ONSITE SEWAGE DISPOSAL SYSTEM

P 558054-B

PROPERTY ADDRESS: 2011 Terrapin Creek Road

From: Oswald, Hank [<mailto:hoswald@howardcountymd.gov>]
Sent: Tuesday, December 15, 2015 1:49 PM
To: Pam Walter
Subject: 2011 Terrapin Creek Road_Plan Review Comment

H0-95-1103

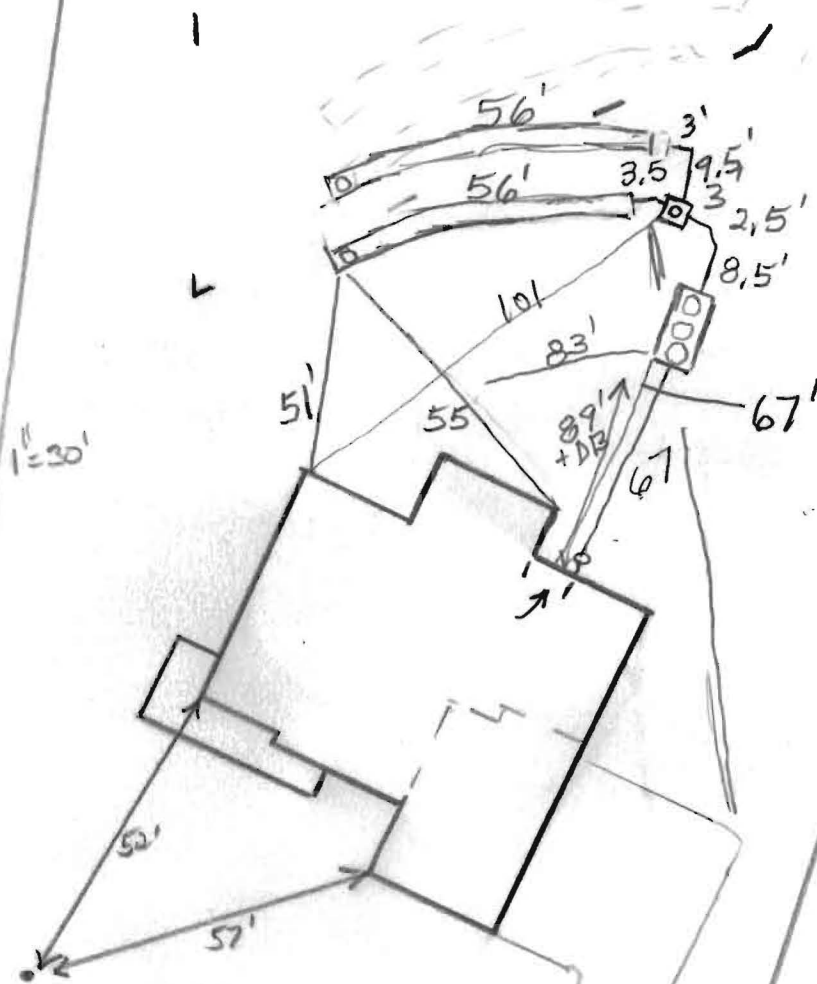
4/27/16 Specs adjusted for deep trench system. BAT location stated. OK to turn tank if needed. Install 2x52' trenches on contour running back towards house. Trenches have slight bend. Call for Insp. (RM)

LOT 3
2011 TERRAPIN CREEK ROAD

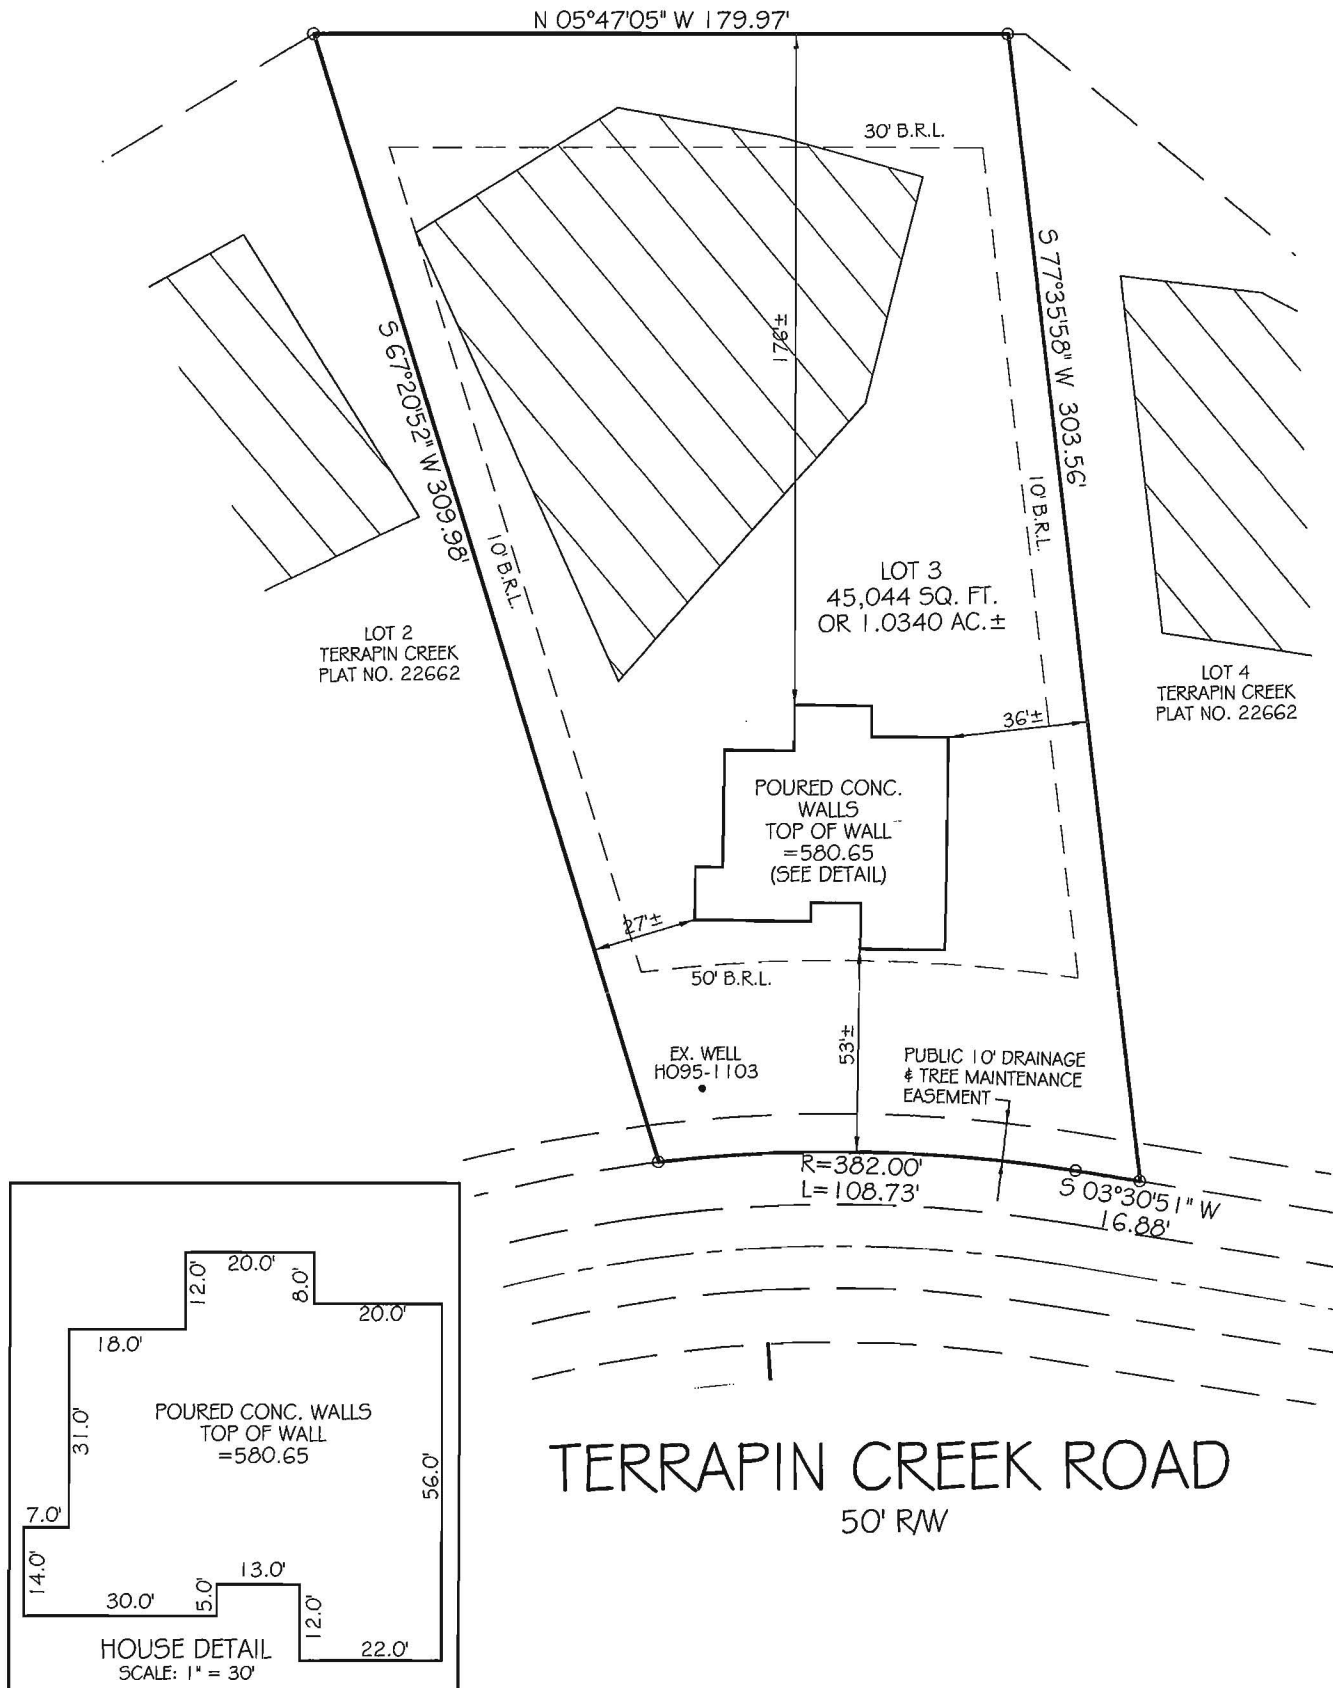
The BAT Plan for the above referenced site is properly sized for 4 BR's but I just wanted to point out that the bottom of the trench could go to 8 feet (instead of 7 feet) according to the septic specs. This would allow for more sidewall credit and a shorter trench length.

If you wish to resubmit, let me know otherwise I am going to sign off on this plan.
